3rd Street Improvements Jefferson Street to Blue Parkway
PROJECT NO. 575

ADDENDUM NO. 3

20' SHEPHERDS HOOK STREET LIGHT DETAIL

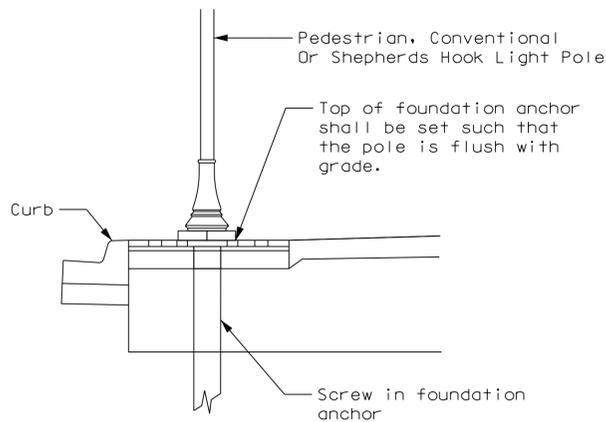
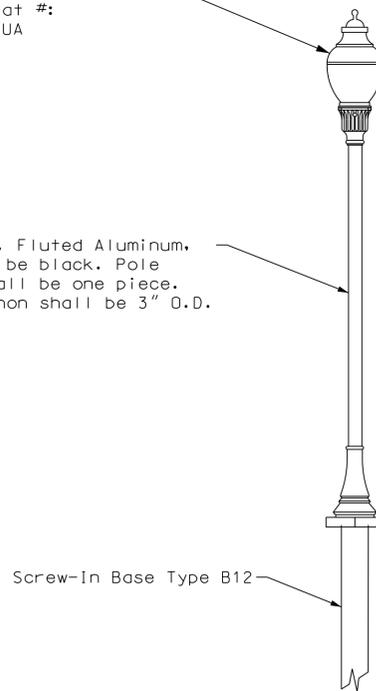
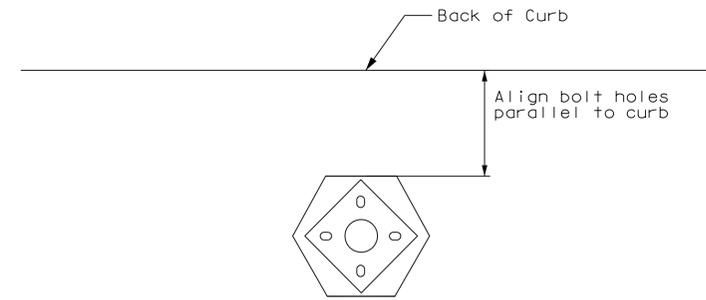
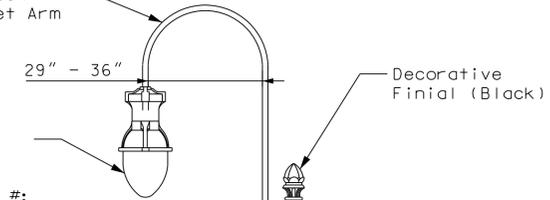
3. Sheet 67 – The dimension for the “Shepards Hook Style Bracket Arm (Block)” on the “20’ Shepards Hook Street Light Detail” has been changed from 36” to 29”-36”, and the clamshell base has been specified for different types of bases. Note: the Shepards Hook light will not be part of the proposed work at this time.

SHEET NO.	TOTAL SHEETS
74	204
DATE PREPARED	
11/4/2024	
ROUTE	STATE
3RD ST	MO
COUNTY	
JACKSON	
CITY	
LEE'S SUMMIT	
PROJECT NO.	
2020-575	
FEDERAL PROJECT NO.	
TAP-3378(402)

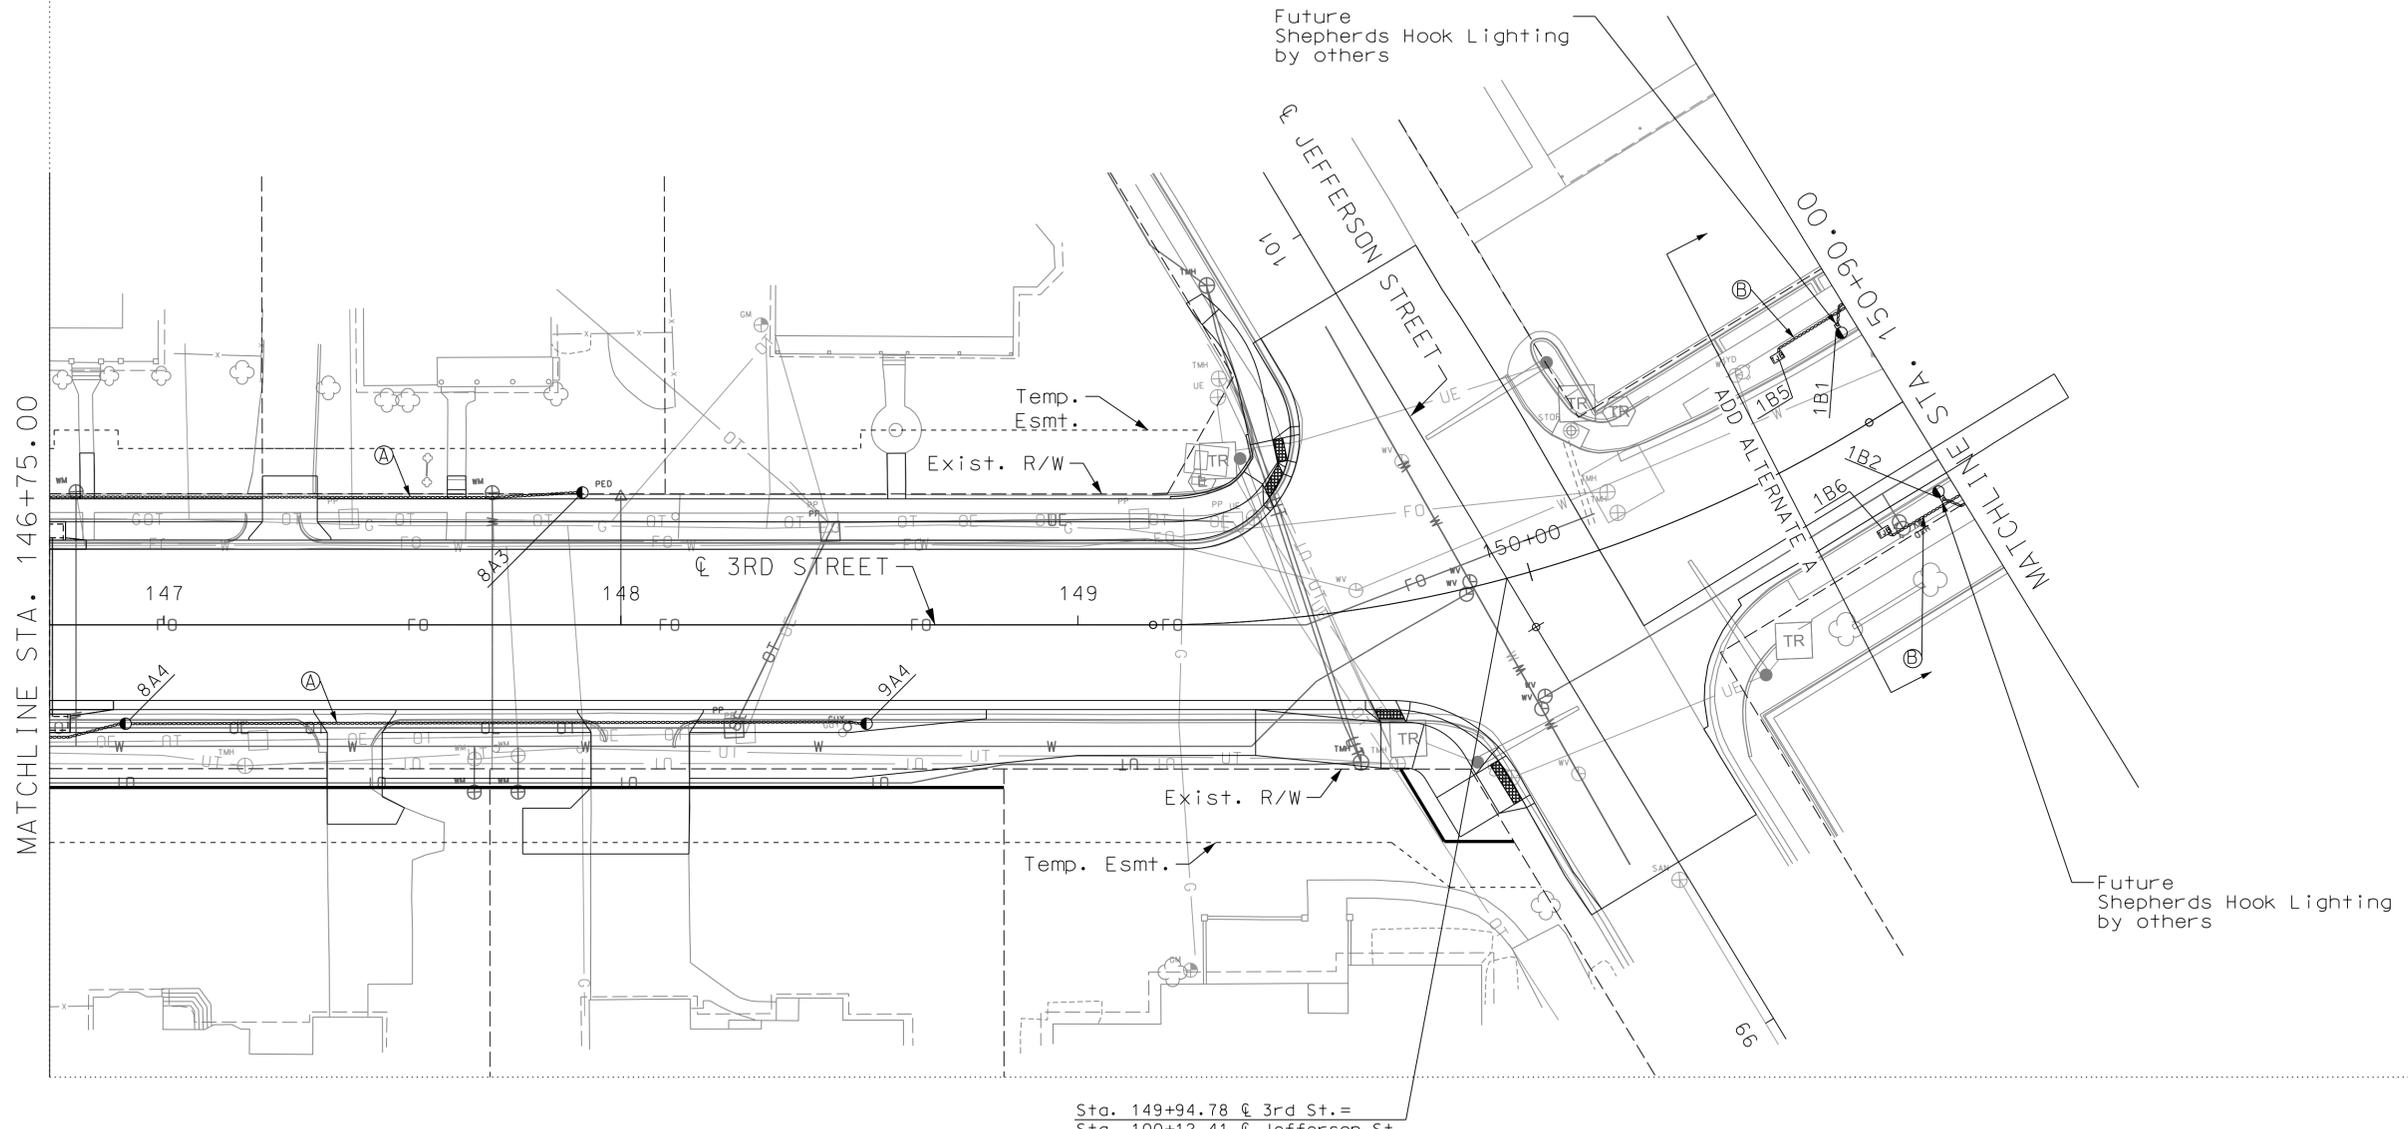
4. Sheet 74 – Light 1B1 & 1B2 have been changed to “Future Shepards Hook Lighting by others”.
5. Sheet 75 – Light 7B2 has been changed to “Relocated Shepards Hook Lighting”

SITE PLAN
L100

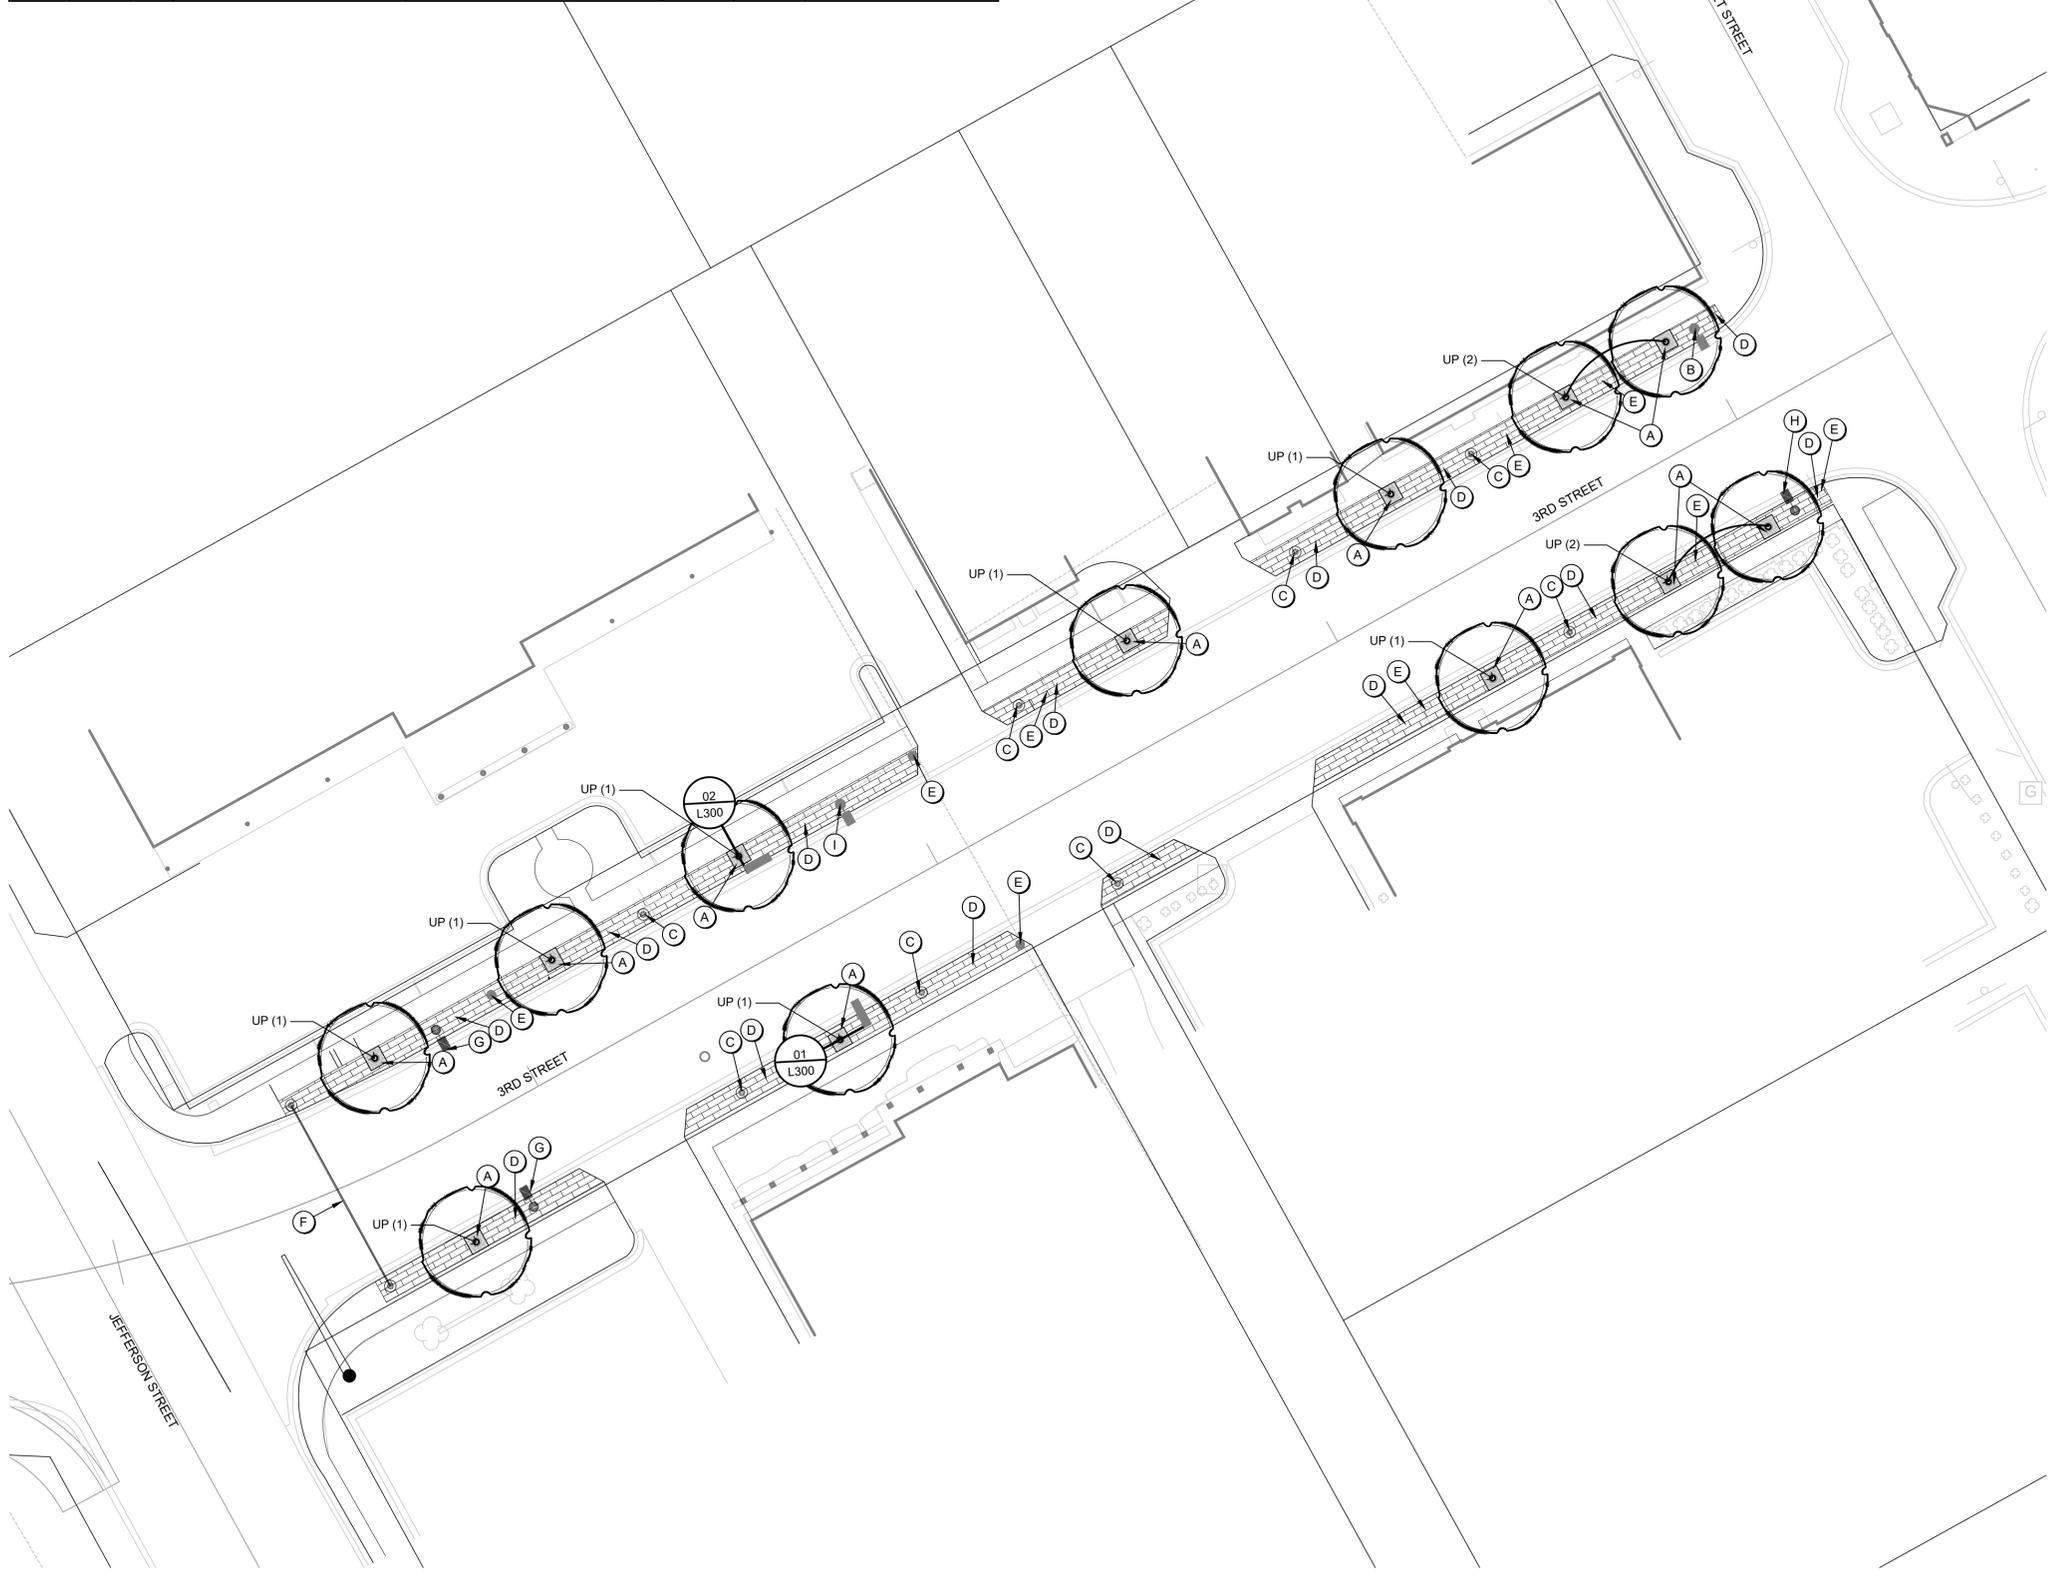
6. Sheet 175 & 176 – Item G in the legend was changed to “Future Shepard’s Hook (by Others)” and the changes on sheets 74 & 75 are reflected with changed callouts at those locations.
